APPLICATION NO.	FILING DATE	FIRST NAMED INVENTOR	ATTORNEY DOCKET NO.	CONFIRMATION NO.
10/813,782	03/31/2004	Kiyoshi Mita	14225-049001 / F1040149US	5223
26211	7590	11/29/2005	EXAMINER	
FISH & RICHARDSON P.C. P.O. BOX 1022 MINNEAPOLIS, MN 55440-1022			CHU, CHRIS C	
			ART UNIT	PAPER NUMBER
			2815

Office Action Summary

DETAILED ACTION

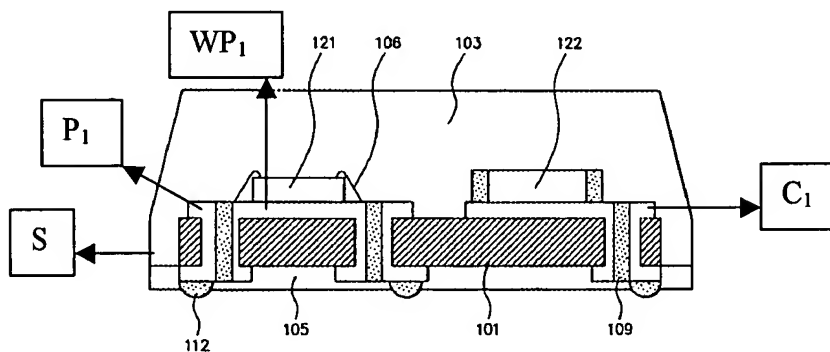
5. Claims 1 – 3, 6 and 7 are rejected under 35 U.S.C. 102(b) as being anticipated by Takeda (U. S. Pat. No. 6,014,318).

Regarding claim 1, Takeda discloses in e.g., Fig. 4 a semiconductor device (The device in Fig. 4), comprising:

- a mounting substrate (105; see Fig. 4 and column 1, lines 33 – 34) having a first main surface (the surface where the chip 121 is formed) and a second main surface (the surface where the external contacts 112 are formed) opposite the first main surface (see Fig. 4);
- a step portion (101) formed in a periphery of the first main surface of the mounting substrate (see Fig. 4);
- a first conductive pattern (C₁ in the above figure) formed on the first main surface of the mounting substrate (105) located inside the step portion (see e.g., Fig. 4);
- a second conductive pattern (112) formed on the second main surface of the mounting substrate (see Fig. 4);

- a semiconductor element (121) fixed to the first main surface of the mounting substrate and electrically connected (by wire 106) to the first conductive pattern (C₁); and
- sealing resin (103; column 1, line 35) covering the first main surface of the mounting substrate and the step portion to seal the semiconductor element (see Fig. 4),
- wherein a side surface (S in the figure of the previous page) of the sealing resin (103) and a side surface of the mounting substrate (105) are located on a same plane (see the figure in the previous page).

Regarding claim 2, Takeda discloses in e.g., Fig. 4 the first conductive pattern (C₁) comprising a bonding pad (the bonding area of C₁ that is bonded to the wire 106) electrically connected to the semiconductor element (121) through a fine metallic wire (106) and a plating line (P₁) extending from the bonding pad to the step portion. Furthermore, the term “plating” is a process designation, and would thus not carry patentable weight in this claim drawn to a product. See *In re Thorp*, 227 USPQ 964 (Fed. Cir. 1985).

Regarding claim 3, Takeda discloses in e.g., Fig. 4 a plurality of the bonding pads (the bonding areas of C₁ that are bonded to the wire 106) being arranged so as to surround the semiconductor element (121; see Fig. 4), further comprising a wiring portion (WP₁; see the figure in the previous page) extending from each of the plurality of bonding pads under the semiconductor element (see Fig. 4).
